DEVELOPMENT ASSESSMENT REPORT - DA245/13 - PROPOSED SUBDIVISION 1 LOT INTO 61, GREAT WESTERN HIGHWAY BOWENFELS NSW 2790

1. PROPOSAL

Council is in receipt of a Development Application DA245/13 from Marrangaroo Estate Pty Ltd for a subdivision of 1 lot into 61 on land known as Lot 702 DP 1135310, Great Western Highway Bowenfels NSW 2790.

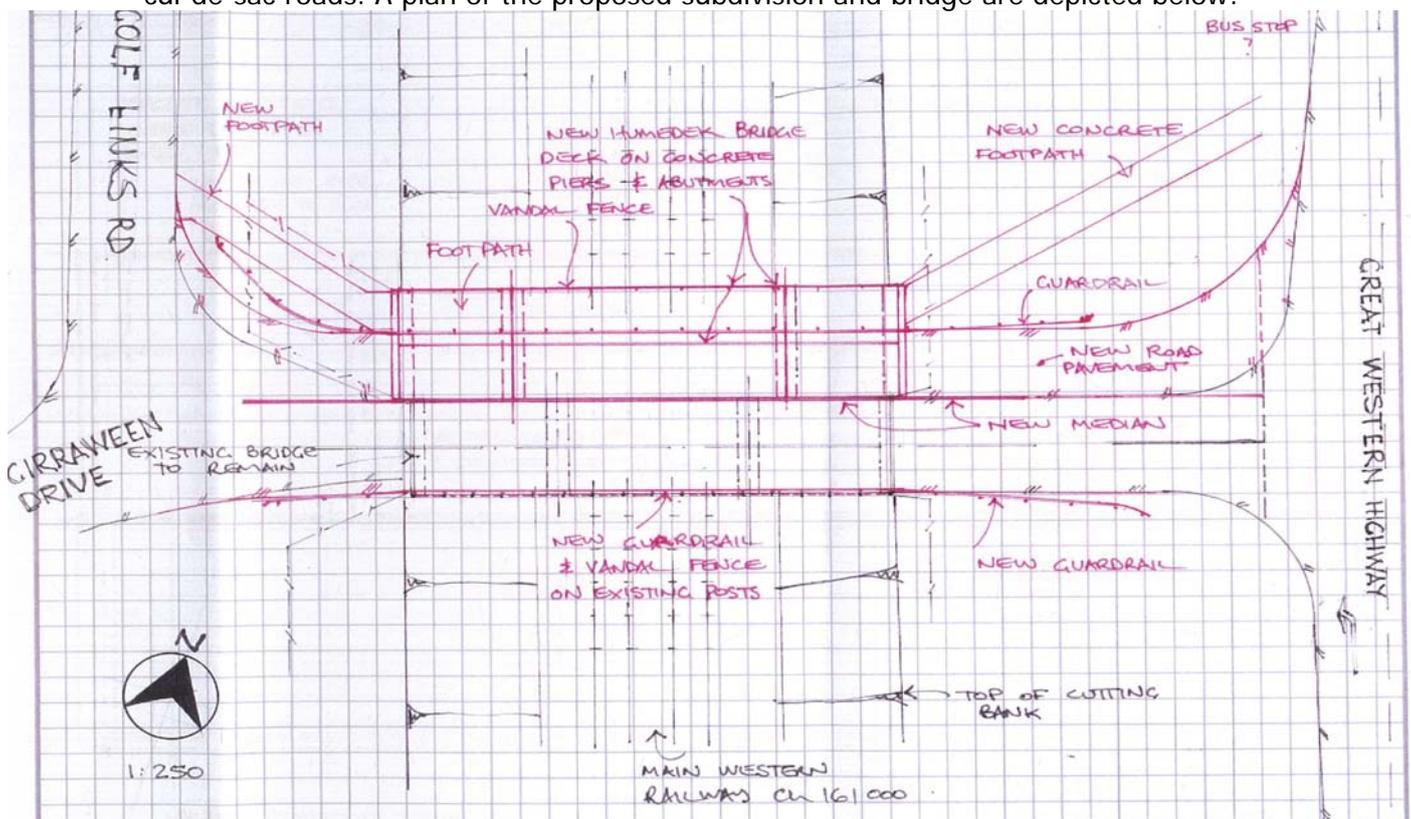
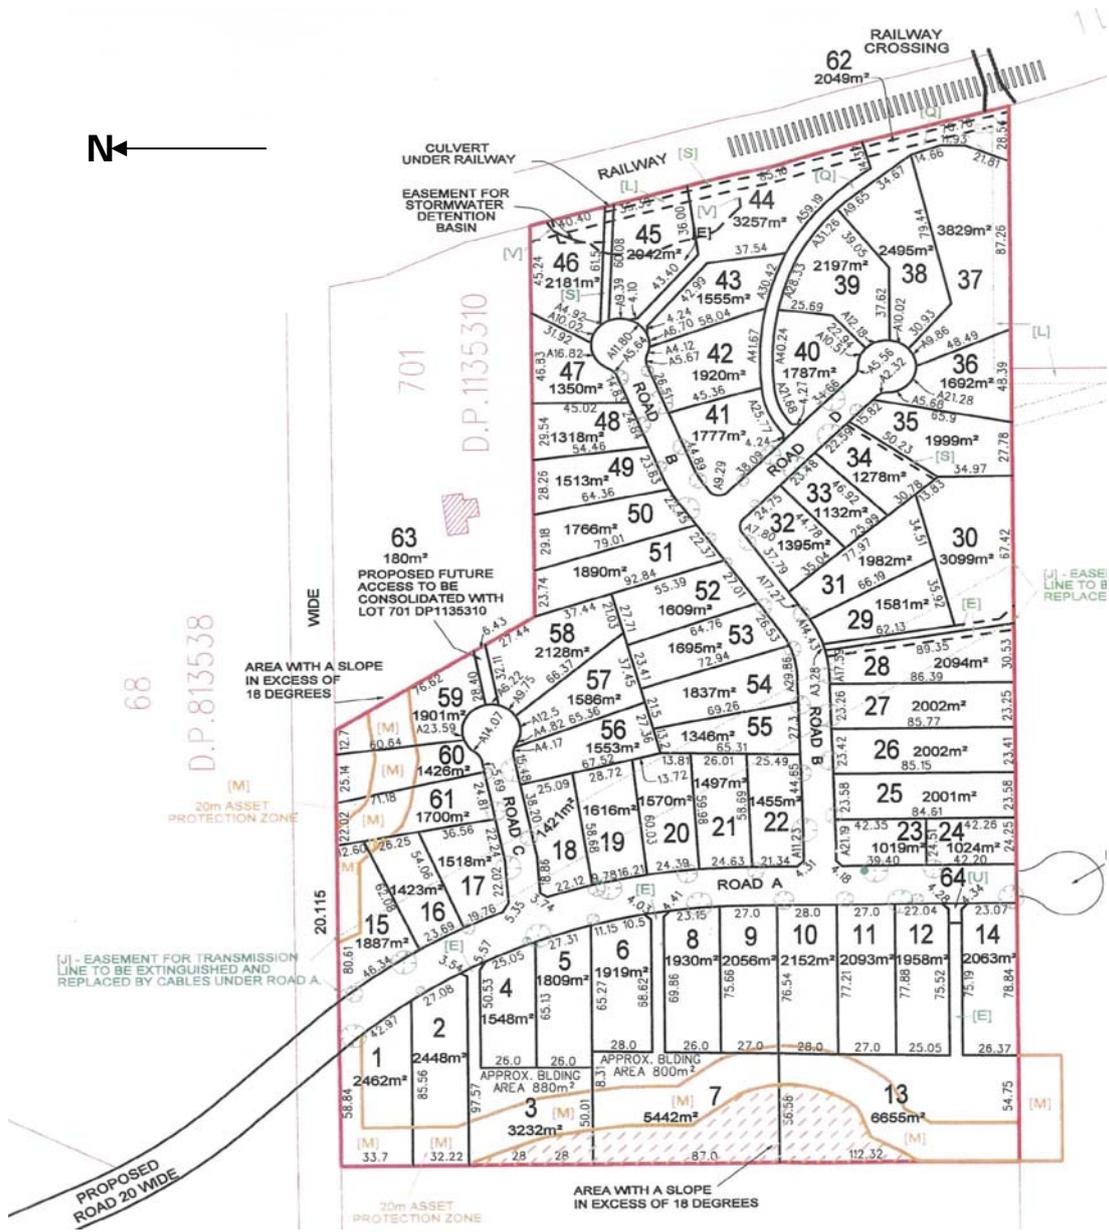
The amended proposal, the subject of this application, is for a subdivision of 1 lot into 61 with a proposed twin bridge to be placed next to the existing bridge access from the Great Western Highway over the Western Railway to Girraween Drive. The proposal also includes the extension of Bundarra Place over Council (Lot 68 DP813538) and Crown Lands (reserved road) properties and the creation of three cul-de-sac roads. A plan of the proposed subdivision and bridge are depicted below:

Blue hashed area depicts the Environmentally Sensitive zone.

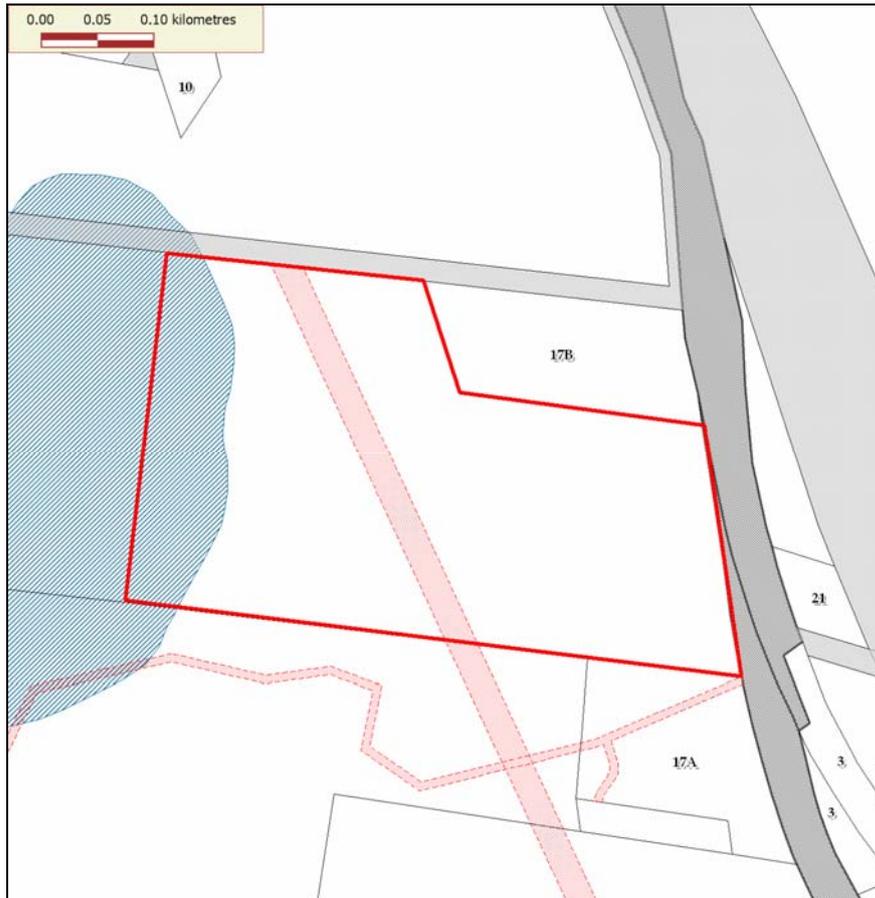
Part of the land is known as environmentally sensitive as per the below mapping:
